Re: Certification Submittal for Final Building Certificate of Occupancy for
Bldg. F @ Petroglyph Plaza, [C-12 / D1G3]
8201 Golf Course NW
Architect's Stamp Dated 12/18/07

TRAFFIC CERTIFICATION

Building "F"
at Petroglyph Plaza
8621 Golf Course NW
Albuquerque, N.M. 87114

SITE PLAN

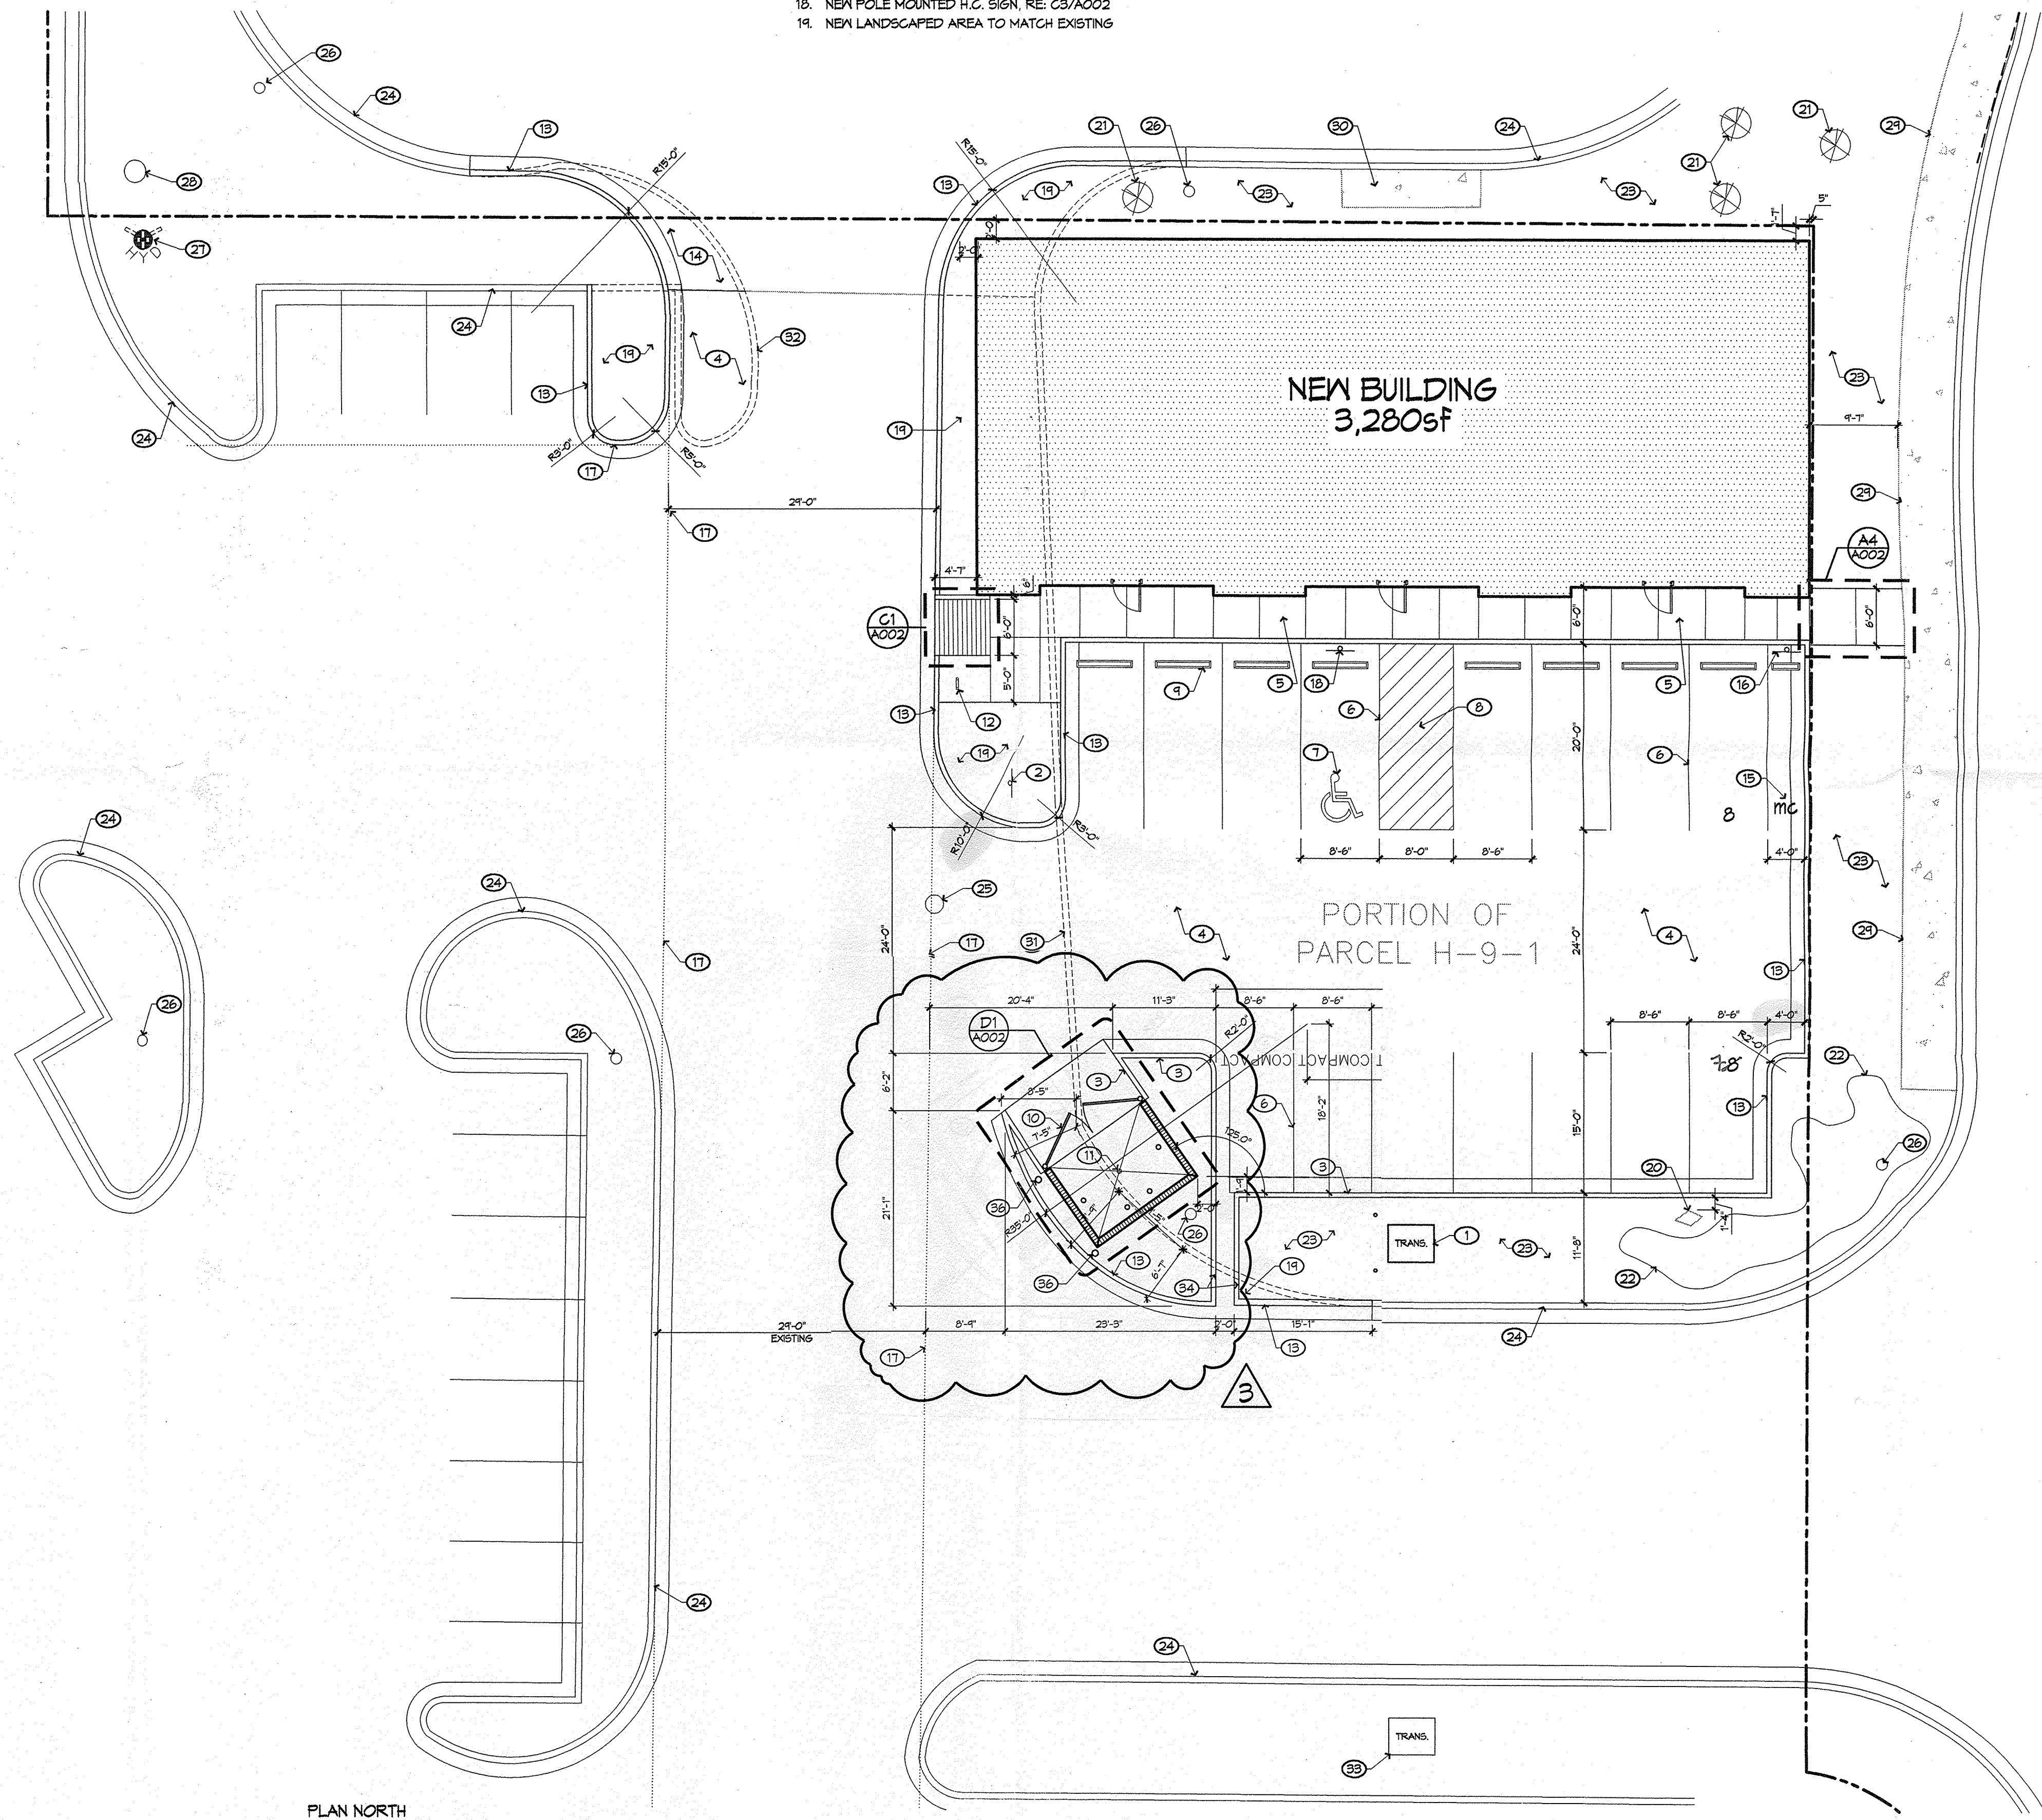
1. The trash enclosure had to be relocated to the east by one parking space to allow for trucks to have a better turning access into the parking lot. See clouded area of attached site plan for revision. This changed the total parking spaces to 15 instead of 16 spaces available, but there are 12 extra spaces just to the west that can be used by occupants in this building. Making the total parking spaces provided 27. 16 spaces are required by code.
